**UPDATE OF
NYE BEACH DESIGN REVIEW OVERLAY**

Memorandum

Date 04-January-2015
Project Name Nye Beach Design Standards Assistance
Project Number 1401039
Attention Derrick Tokos
City of Newport, Community Development
Address 169, SW Coast Hwy
Newport, OR 97365
Email D.Tokos@theCityofNewport.net
FAX (541) 574-0609
Subject Suggested Revisions to Nye Beach Design Guidelines and Standards

Illustration #8: Commercial Buildings

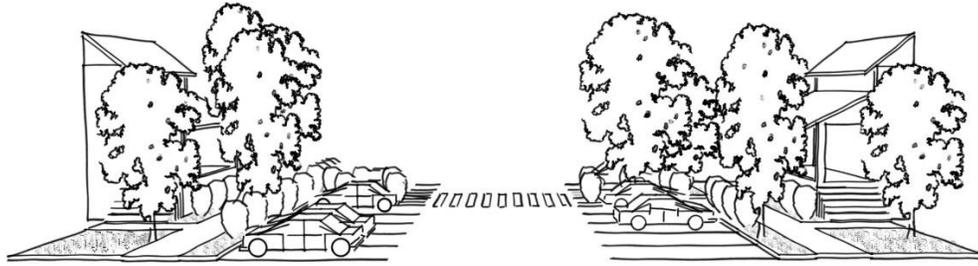
The intent of the Design Guidelines is to provide for variety in building shape, size, roof lines and design features – allowing architectural expression within a set of established design styles and types.

Illustration #9: Parking and Pedestrian Layout

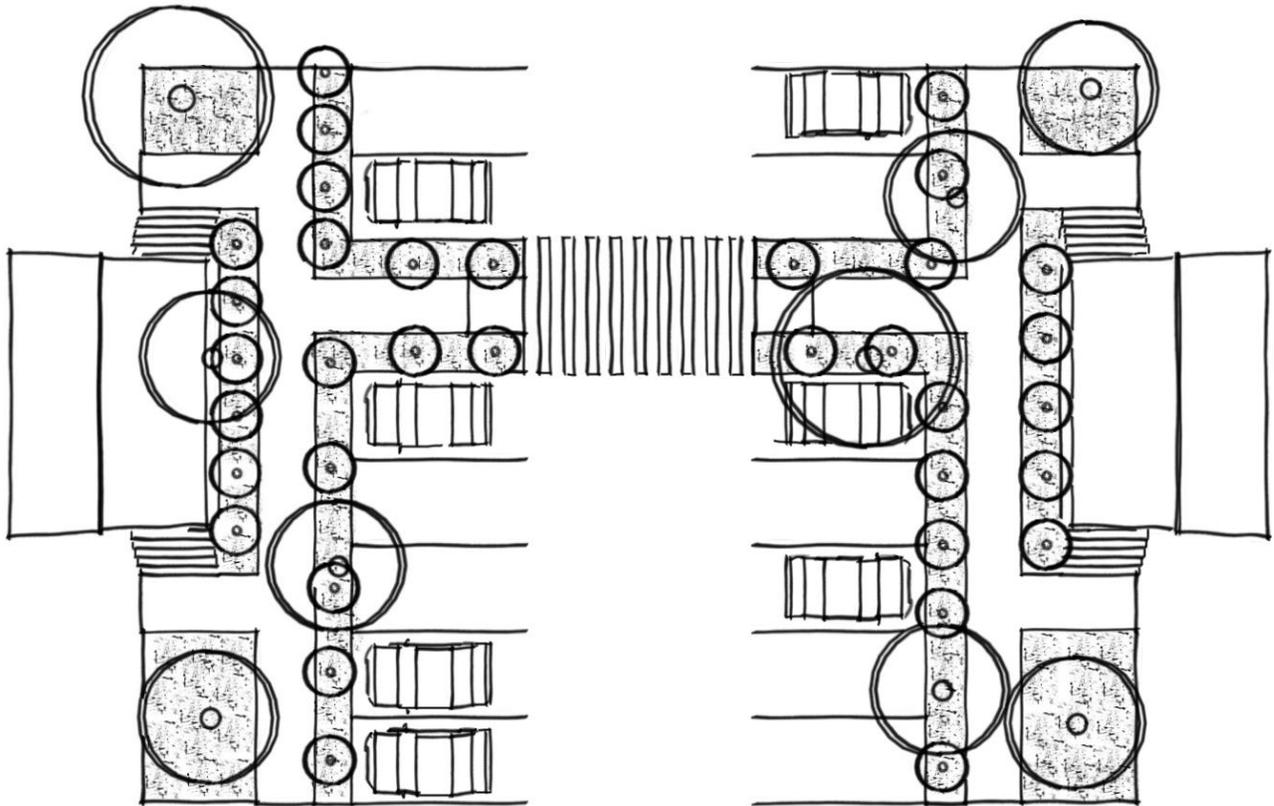
The illustration above shows an Interior parking lot. Note that the pedestrian pathways are separated from the vehicle travel areas. Where the pathway crosses the parking lot, a landscaped area extends from each side to mark the crossing areas. Additionally, the crossing area is clearly marked. Specialty pavers could also be used to mark the pedestrian crossing area. Trees provide screening for the parking lot. A short hedge (3-4 feet) around the parking lot in the landscaped area would provide additional screening and would further separate the pedestrian and vehicle areas. Breaks in the hedge along large parking lots could be provided to allow easier access to and from parked vehicles.

Illustration #__: Massing of larger buildings

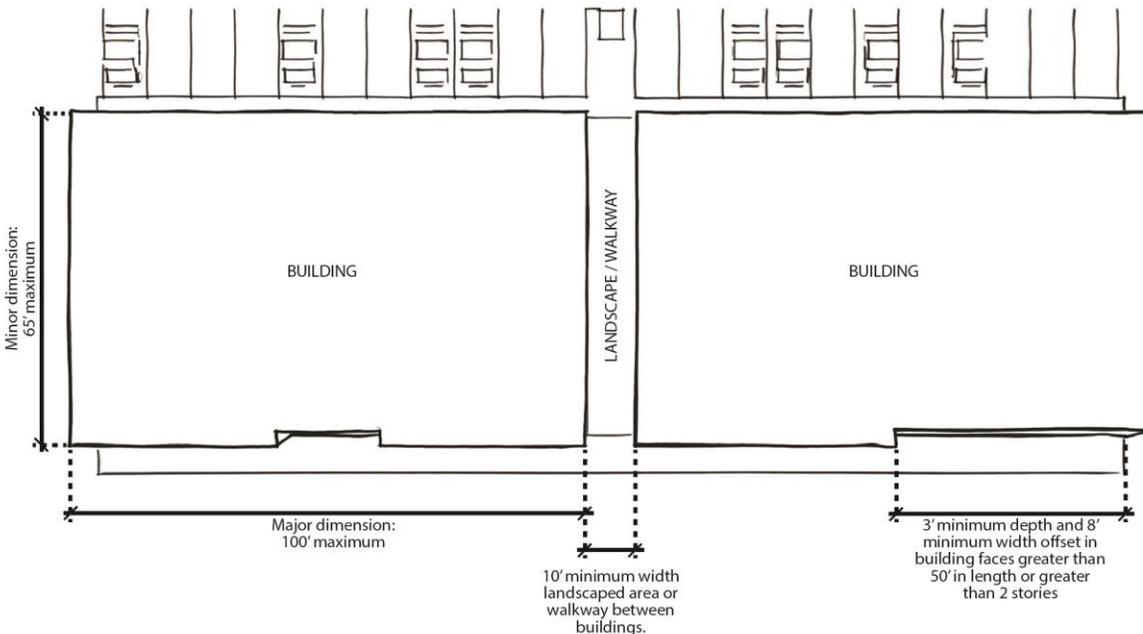
This illustration shows several massing requirements:

- Maximum frontage lengths in each direction
- Required offsets in buildings
- Separation of buildings for landscape and/or parking access/pedestrian ways

Illustration #__ : Transition materials at inside corners, rather than outside

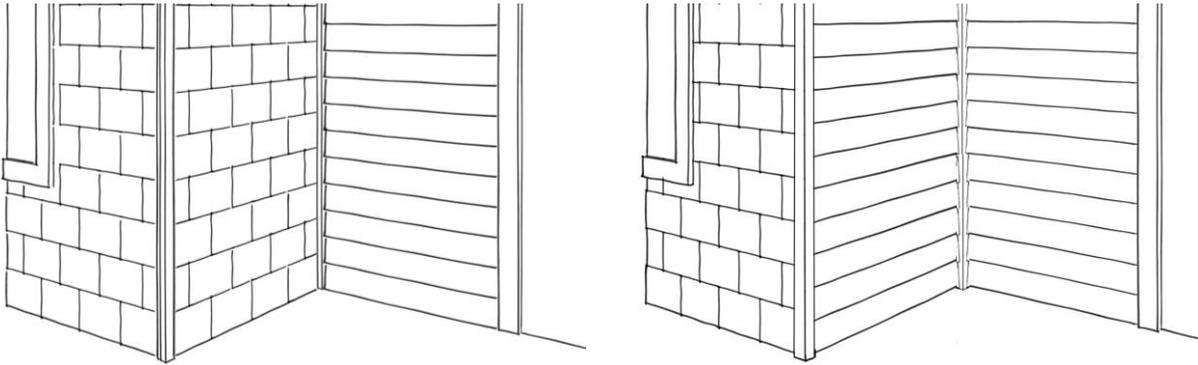
Where materials are changed on facades, the transition should be made at “outside” corners, as at left, rather than at “inside” corners, as at right. This design strategy is in keeping with the traditional styles found in the district, as they express volumes of rooms and bays, rather than wall planes.
